motionarchitecture t: +44 (0)759 007 7000 e: suraj@motionarchitecture.com 155 Carlton Avenue East, HA9 8PU			
Denewood, Chorleywood Road, WD3 4EP SCALE: 1:1250 @A4 DWG NO: DW_001 REV: 02 DATE: FEB 2025			
This drawing is copyright		Do Not Scale	All dimensions to be checked on site

Denewood, Chorleywood Road, WD3 4EP
SCALE: 1:200 @A3 DWG NO: DW_020 Proposed ground floor plan
REV: 01 DATE: FEB 2025

Proposed first floor and roof plans
REV: 02 DATE: JULY 2025

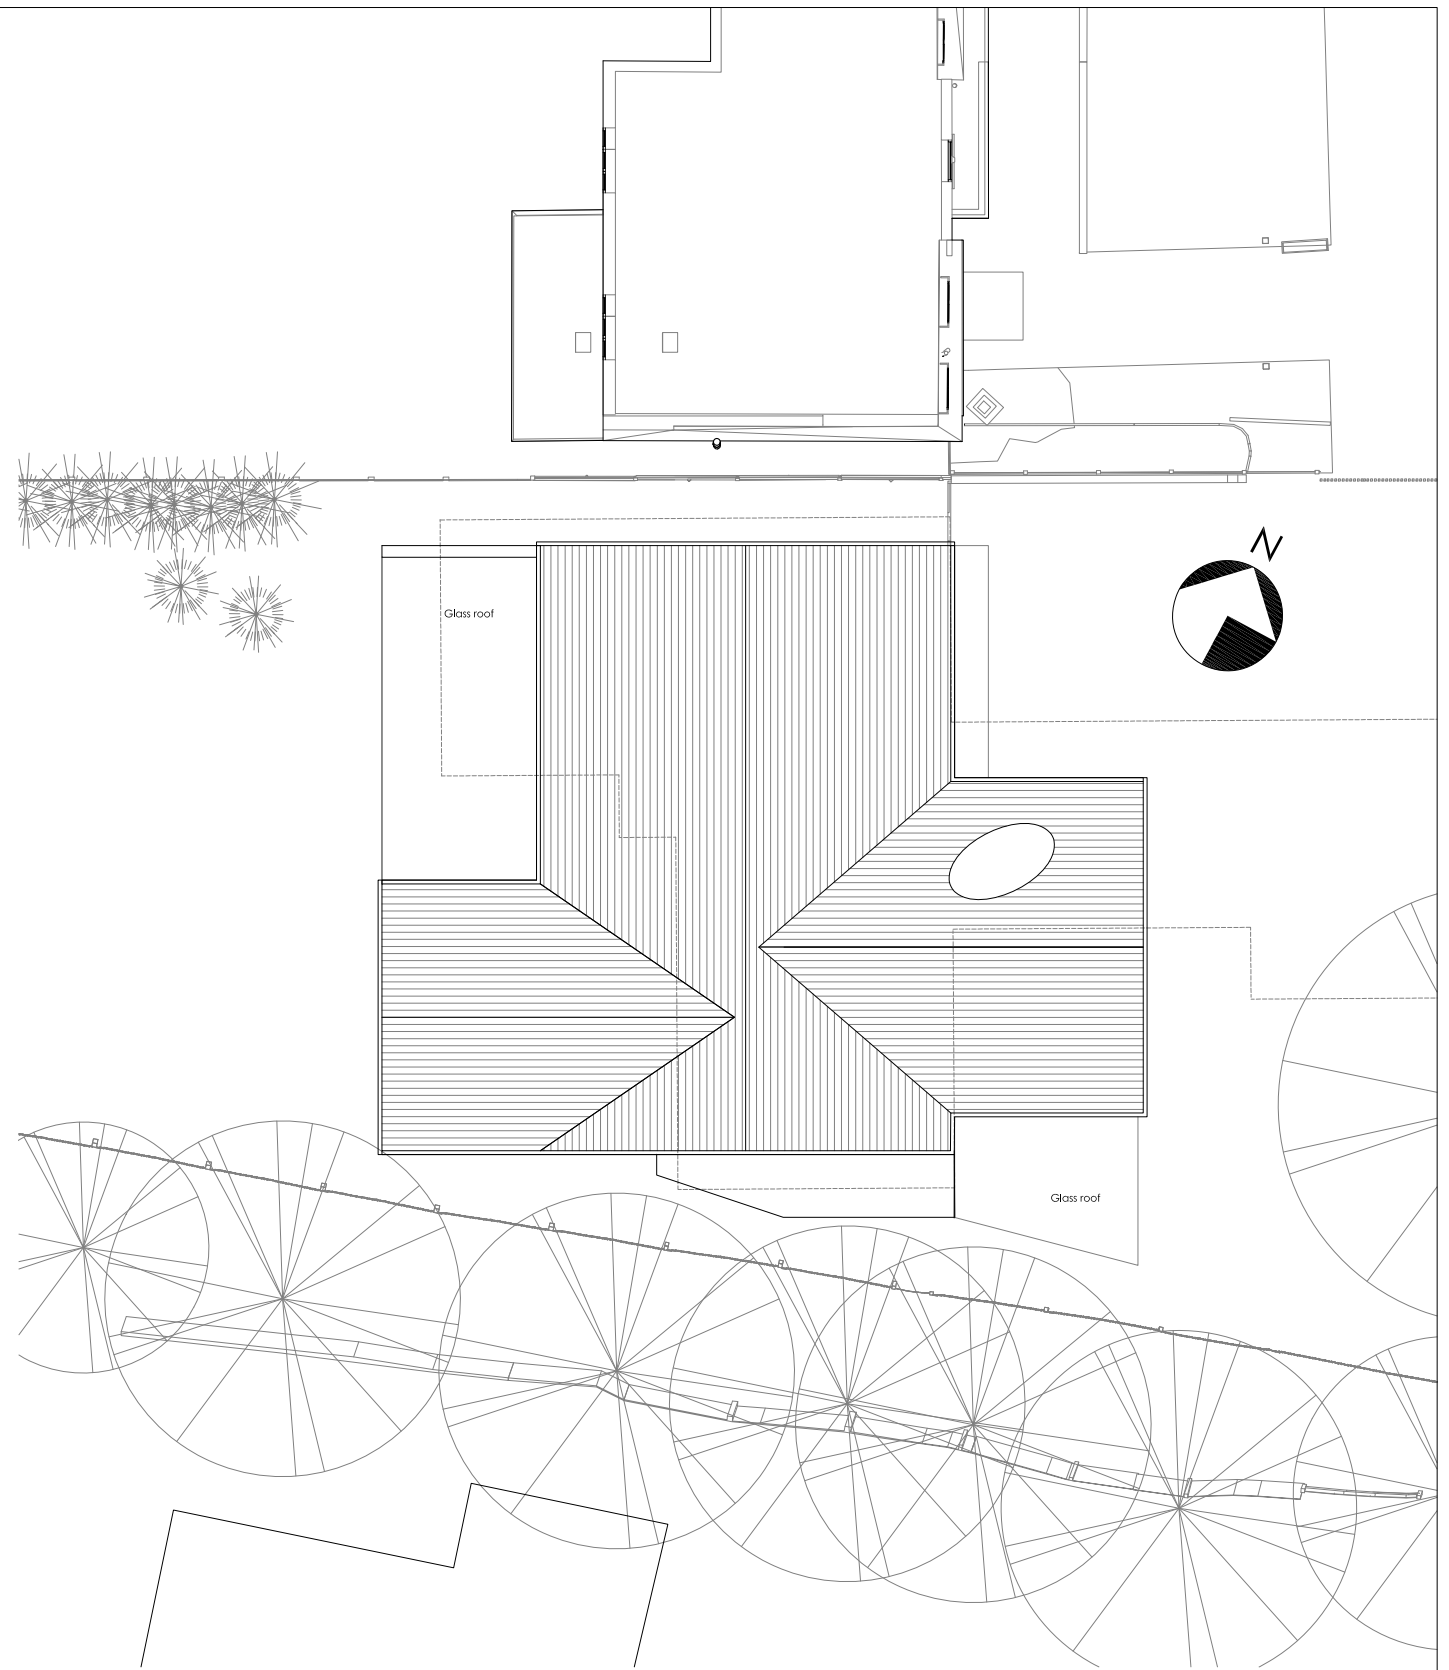
Rev 02: 07/07/2025 - Main ridge height reduced by 400mm based on planner's comments.
Rev 01: 14/02/2025 - Side elevation balcony omitted & rear balcony added based on planner's comments.

Revised side elevations
 REV: 03 DATE: JUN 2025

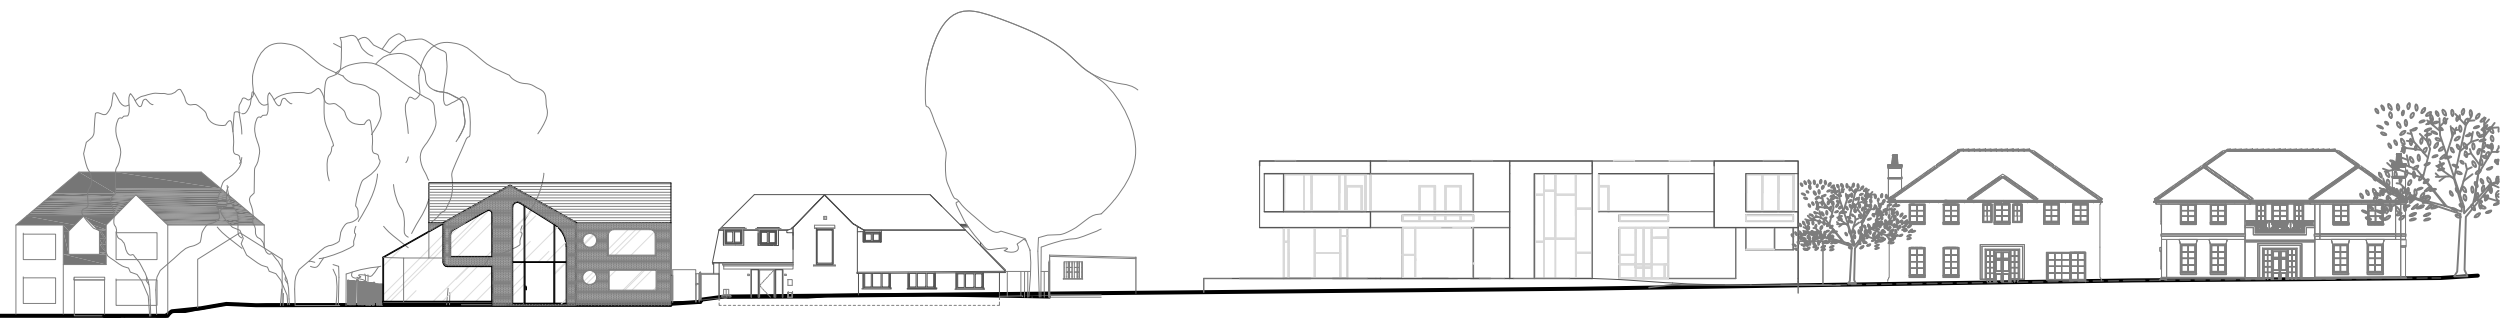
Rev 03: 07/07/2025 - Main ridge height reduced by 400mm based on planner's comments.
 Rev 02: 01/07/2025 - overall height reduced by 500mm and gable facing sunnyside hipped based on planner's comments.
 Rev 01: 14/02/2025 - Side elevation balcony omitted & rear balcony added based on planner's comments.

Revised Street scene context elevation
 REV: 02 DATE: JUN 2025

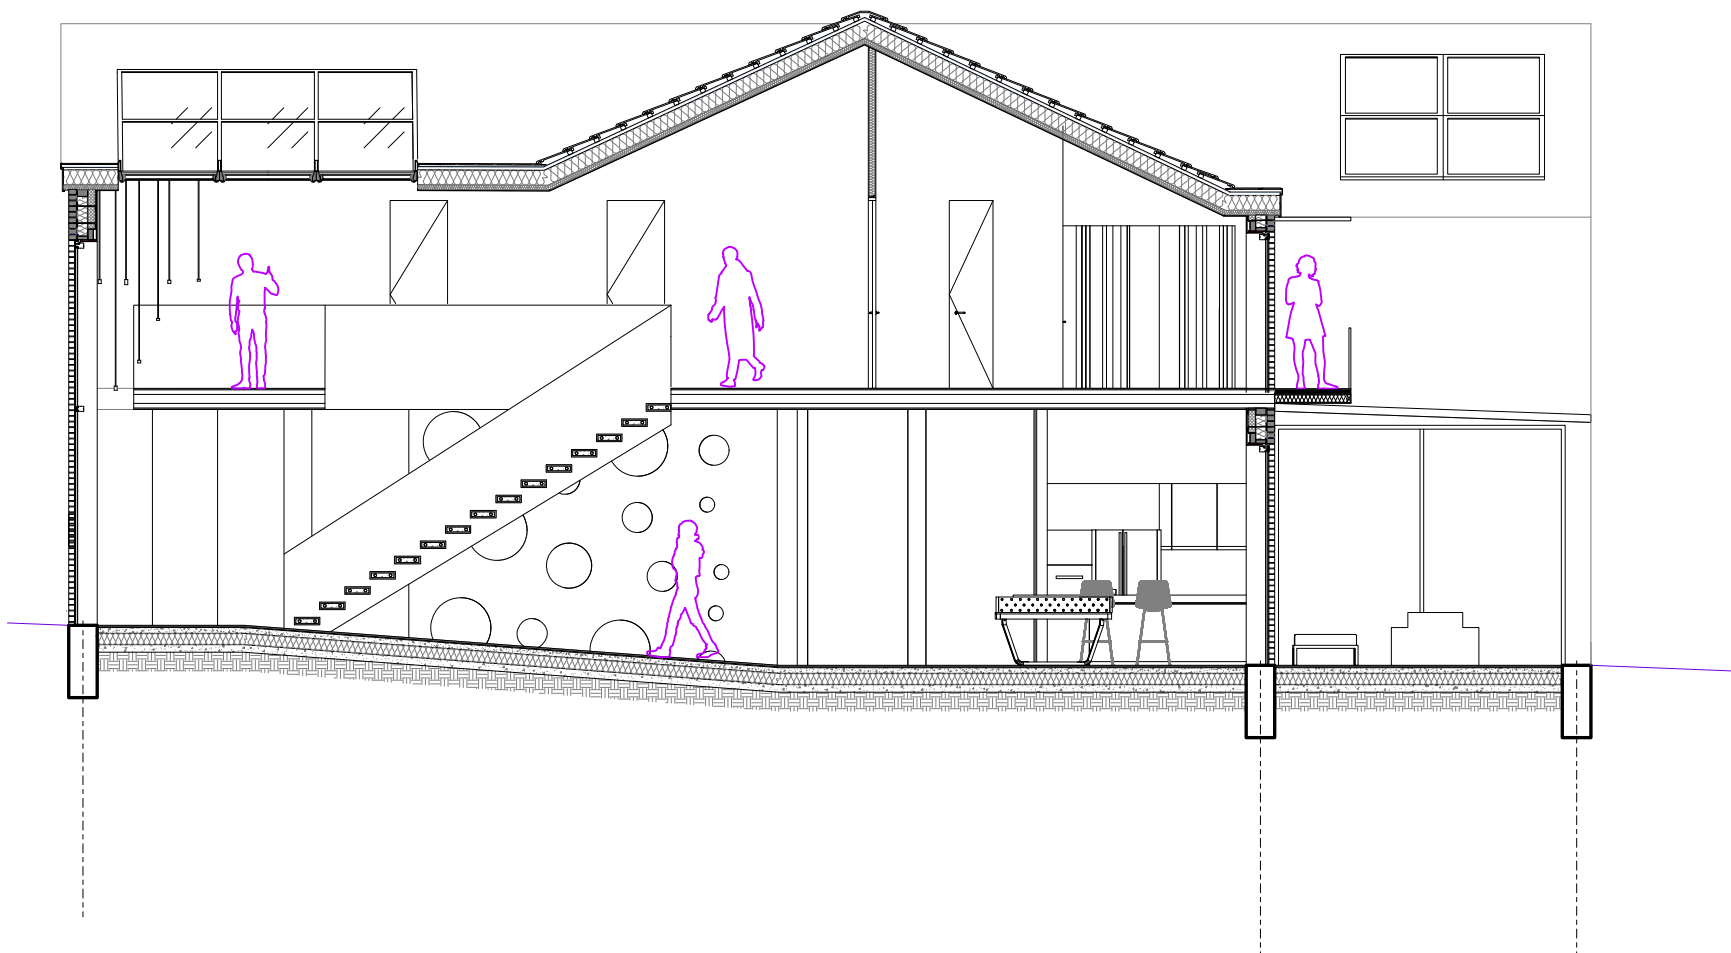
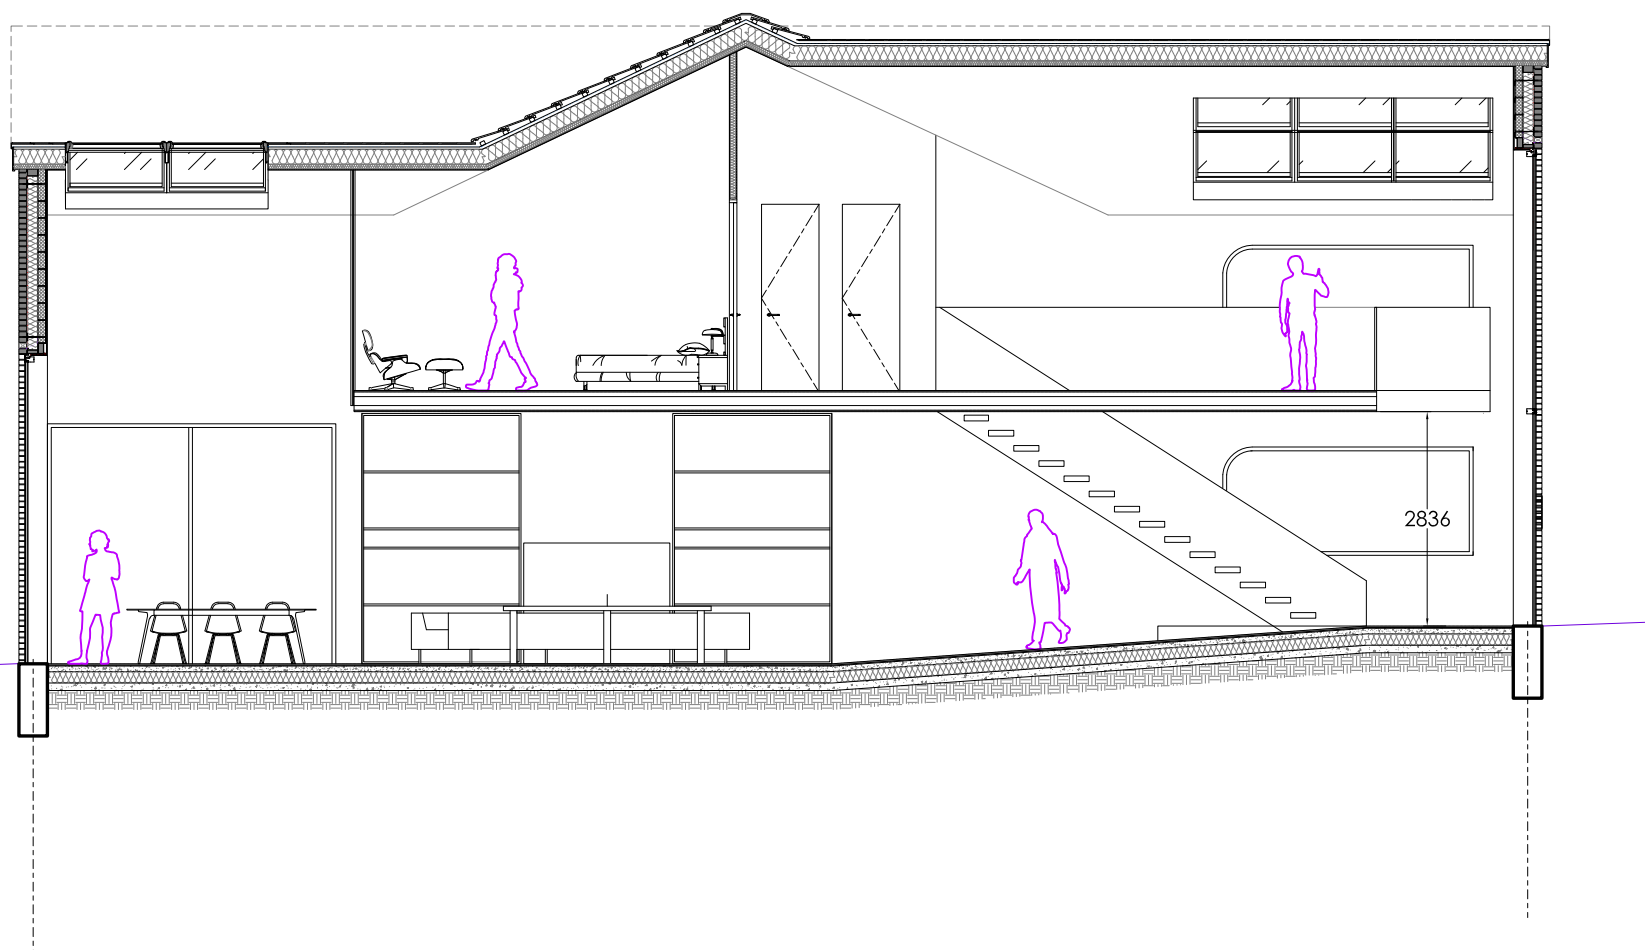
Rev 02: 07/07/2025 - Main ridge height reduced by 400mm based on planner's comments.
 Rev 01: 01/07/2025 - overall height reduced by 500mm and gable facing sunnyside hipped based on planner's comments.
